## SF – 082

DATE: January 08, 2019  
TO: All Service and Parts Managers  
SUBJECT: PSR-01 Collector Box Pressure Switch Relocation Kit

*Open Stand Pipe (Anti-siphon air vent example without cooling coil)*

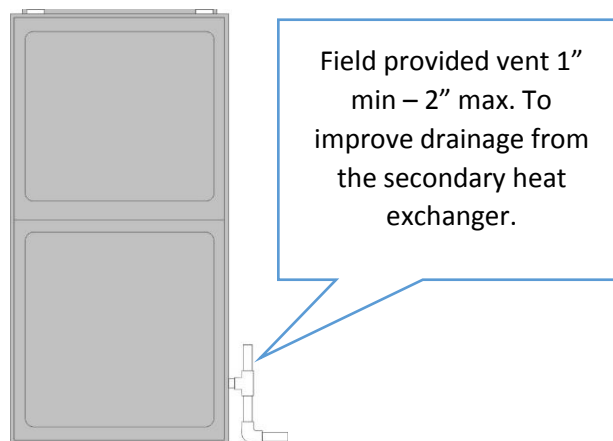
1. Drain line termination from side of furnace is the correct size  $\frac{3}{4}$ " and sloped as per I.O. manual.
2. Drain termination must vent with an anti-siphon tee before condensation goes into the condensate pump or termination drain. See example in figure below.
3. Ensure condensate hoses are sloped and draining away from the collector box.
4. Ensure condensate is draining properly from the drain trap, no blockage.
5. No double trapping of the drain line into a condensate pump or termination at a floor drain.
